SERVICE BULLETIN

Classification: EC20-023	Reference: NTB20-083	Date: November 24, 2020
-----------------------------	-------------------------	----------------------------

2019-2020 ALTIMA; DTC P2015 OR P2004 STORED DURING COLD WEATHER

APPLIED VEHICLES: 2019-2020 Altima (L34)

Figure 1

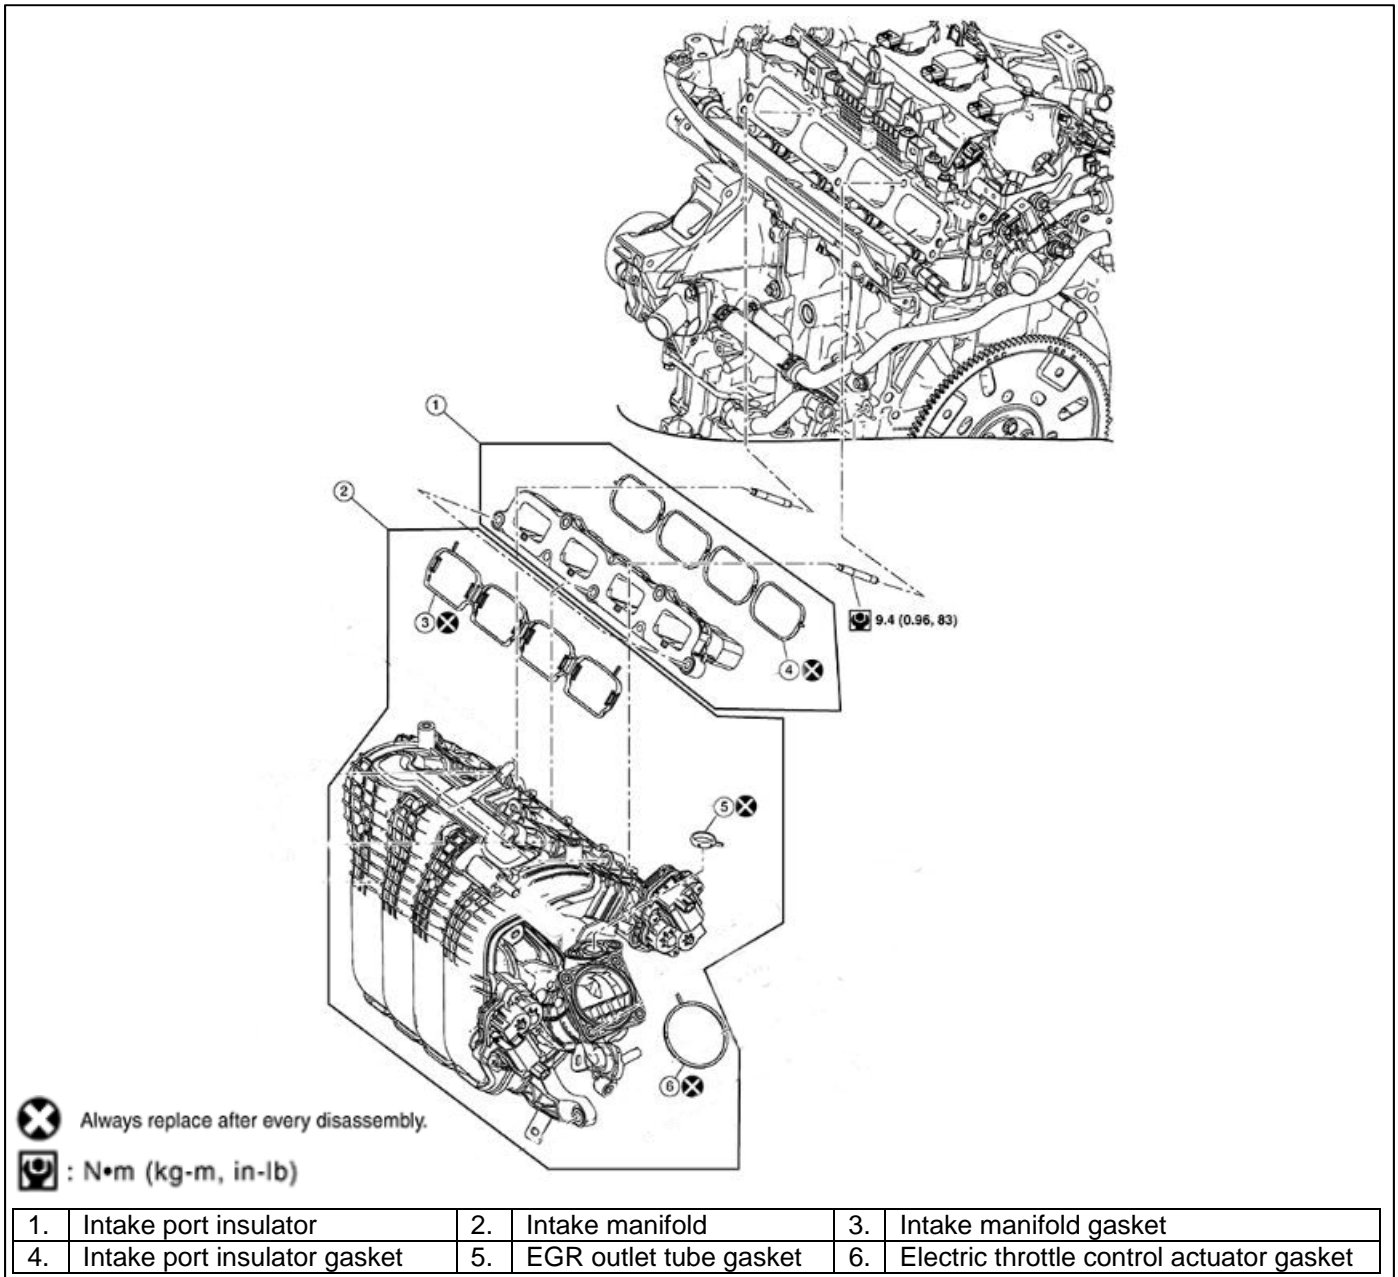
1. Replace the intake manifold.

- For intake manifold replacement, refer to the ESM section: **ENGINE > ENGINE MECHANICAL > PR25DD > REMOVAL AND INSTALLATION > INTAKE MANIFOLD.**
